Historic Architectural Review Commission
Staff Report for Item 4

To:	Chairman Haven Burkee and Historic Architectural Review Commission Members
From:	Enid Torregrosa-Silva, MSHP Historic Preservation Planner
Meeting Date:	September 27, 2022
Applicant:	Robert A. Jensen, Owner
Application Number:	H2022-0030
Address:	411 Louisa Street

Demolition of non-historic side and rear roof overhangs. Partial demolition of front, rear, and side walls of existing rear addition.

Graphic depiction of 1962 Sanborn map and one and a half-story portion of the house over the site's survey.

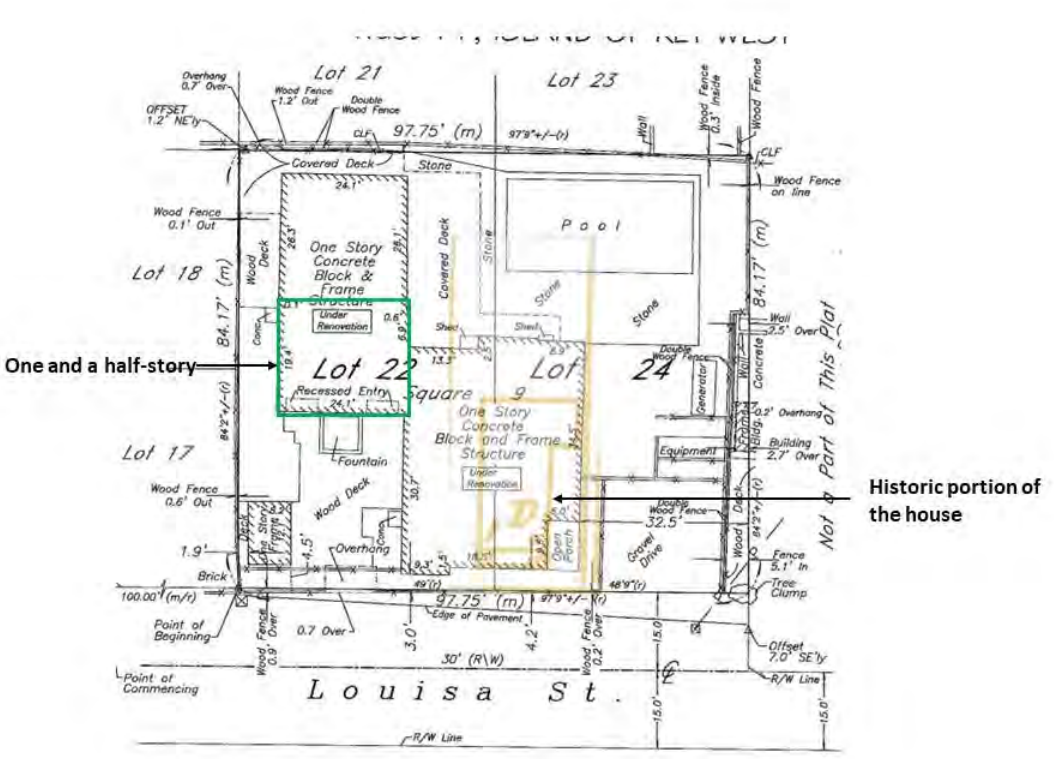
The site under review contains one principal house and an accessory structure located on the southwest portion of the lot. A swimming pool and decks are found behind a one-story structure. By reviewing the Sanborn maps, on the east side of the existing building there are portions of a one-story historic house. Additions to the building were done to its rear east and west side, making the historic building almost non-existing. Staff believes that the latest additions were built in late 1990's. A four feet picket fence with a gatehouse can be found in the front yard. The site has a deck in front of the one and a half-story structure.

Most of the residential complex is one-story, except for the southwest portion, which is one and a half-story. The half story is an open vaulted ceiling that includes a living room. Analyzing the urban context, the house to the west side is on a corner lot and is one and a half story non-historic structure. There are two one-story houses abutting the rear yard of the site under review; 404 Catherine Street is non-contributing, and 410 Catherine Street is a contributing resource to the historic district, build circa 1912.

Proposed demolition for non-historic portions of the house is highlighted in red.

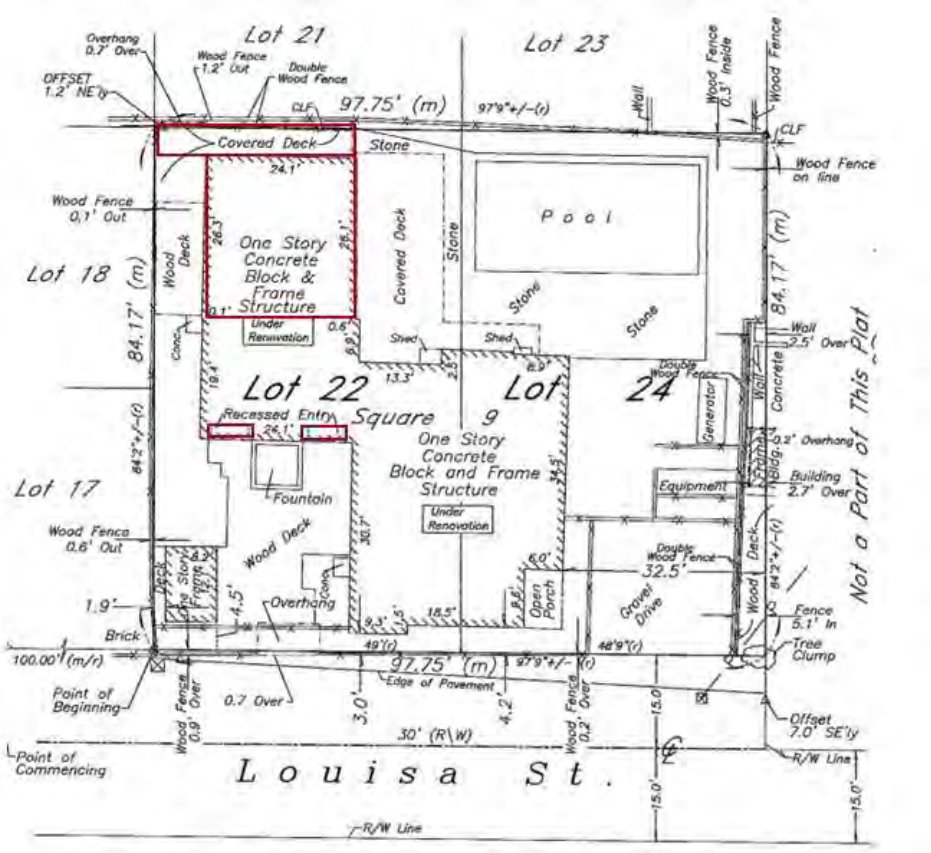
The Certificate of Appropriateness under review proposes the demolition of a non-historic rear addition and partial front walls on the first floor of the southwestern part of the existing building. The application also includes the demolition of rear and side roof overhangs attached to the rear one-story addition. The submitted plans include new treatment of first floor front elevation of the southwestern portion of the house as well as a two-story rear addition.

It is staff's opinion that the non-historic elements under consideration are not significant structures that can define the overall historic character of the neighborhood. The site has no historic structures.

The structures under review are not historic and their demolition will not affect any urban relationship acquired through time.

It is staff's opinion that the structures in question are not significant elements to the site or surrounding neighborhood.

It is staff's opinion that the structures under review will not qualify to be contributing to the building or site in a near future.

Staff finds that the requested demolition of non-historic elements are in accordance with current ordinance for demolitions under the LDR's. If approved, this will be the only required reading.
